TECHNICAL NOTE 1

DATE:	19 January 2022	CONFIDENTIALITY:	Public
SUBJECT:	Long Copse Lane - Lighting Response to SDNP, HBC and NE		
PROJECT:	Long Copse Lane	AUTHOR:	P. Batchelor
CHECKED:	N. Griffin	APPROVED:	A. Howard

This short technical note has been produced in response to comments received from both Hampshire County Council (HCC) Ecology (27th October 2021), South Downs National Park (SDNP) (9th November 2021) and Natural England (6th December 2021) in relation to Outline Planning Application APP/21/00893 Land North of Long Copse Lane.

Figure 3 – Northern Buffer Zone Grid 1 (horizontal grid)

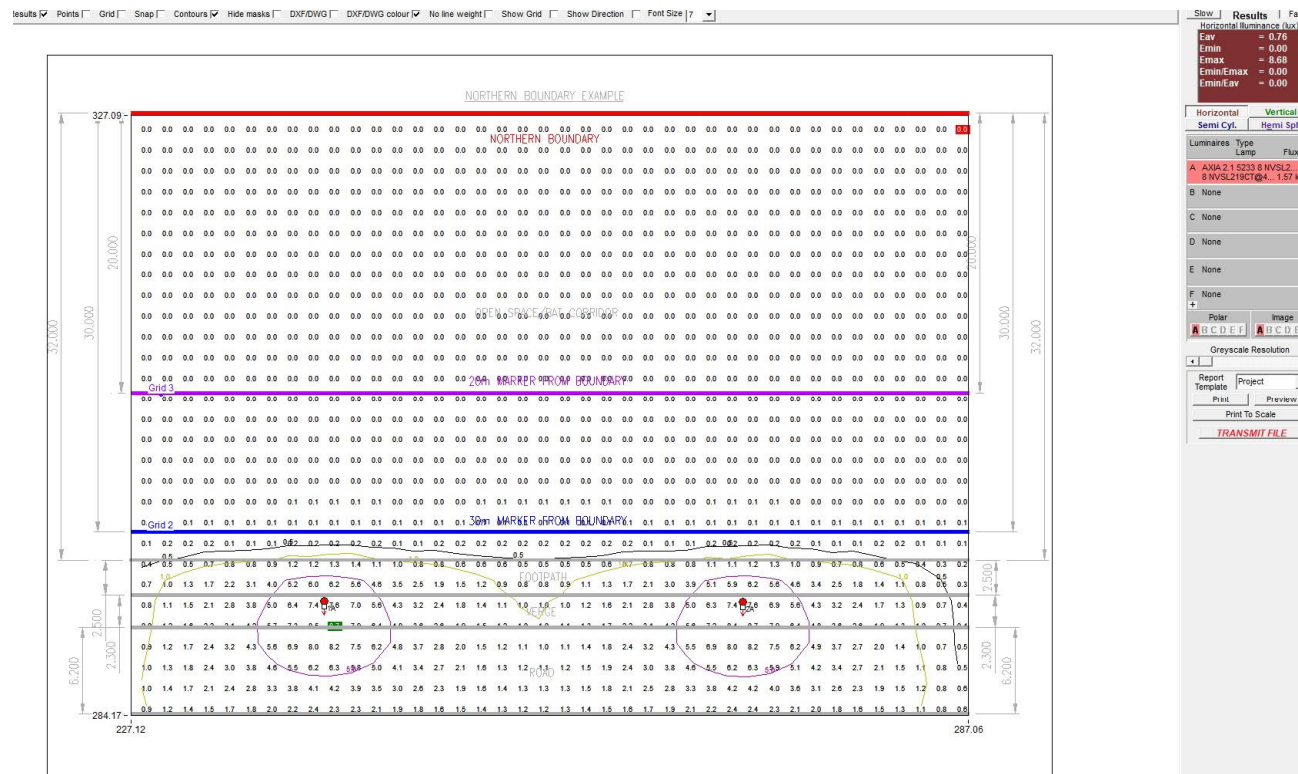
The potential impact of lighting on these buffers is also of concern. The submitted Lighting Assessment includes outline details of proposed lighting, but the level of detail required to assess the impacts of lighting on the proposed buffer and adjacent habitats is not provided. It is hoped to provide unlit areas adjacent to the buffers but this is not guaranteed.....

A detailed lighting strategy should also be submitted to and approved by the HCC ecologist which outlines how light spill will be prevented in the unlit bat buffers.

WSP has produced two calculations that are representative of and proof of concept as to how lighting can be provided for the purposes of resident's safety whilst minimising spill light to levels identified that are required for Bechstein's and other light sensitive species within the proposed ecological buffer zones at Long Copse Lane. The presented calculations cannot and do not cater for additional mitigation such as baffles or screening provided by existing or proposed trees; as such the calculations very much represent a worst-case scenario.

- Minimum of 20 metres from site boundary below 0.2 lux on vertical and horizontal (indicated as the **purple** grid in the calculation screen shots)
- Minimum of 30 metres from site boundary below 1 lux on vertical and horizontal (indicated as the **blue** grid in the calculation screen shots)

Figure 10 – Axia 2 Polar Diagram

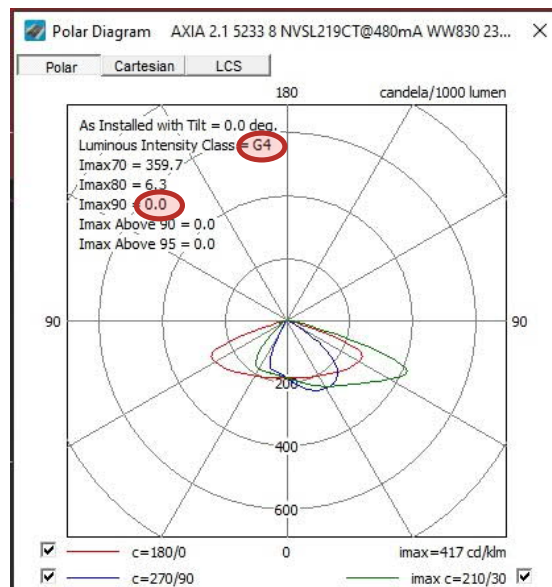
'With the intended luminaire, it is likely that the upward light ratio will be close - if not, will be – to zero. Although the development is within an E2 zone, we would prefer to see the luminaires installed at the E1 requirements with zero upward light. We request this is given further consideration.'

As highlighted in the HCC response, calculations have been carried out utilising an Urbis Schreder Axia 2 LED luminaire. When installed at an inclination of zero degrees to the finished surface, the luminaire is compliant with G4 class of BS EN13201-2:2015, having a ULR of 0 i.e. no light above the horizontal (90°), ensuring compliance with the GN01 E1 ULR requirement of 0.

Polar diagram of Axia 2 file reference AXIA 2.1 5233 8 NVSL219CT 480mA WW830 13W 7x5 II-Short 400952 Integrated lenses Back louvers 230V EF. Compliant figures circled in red.
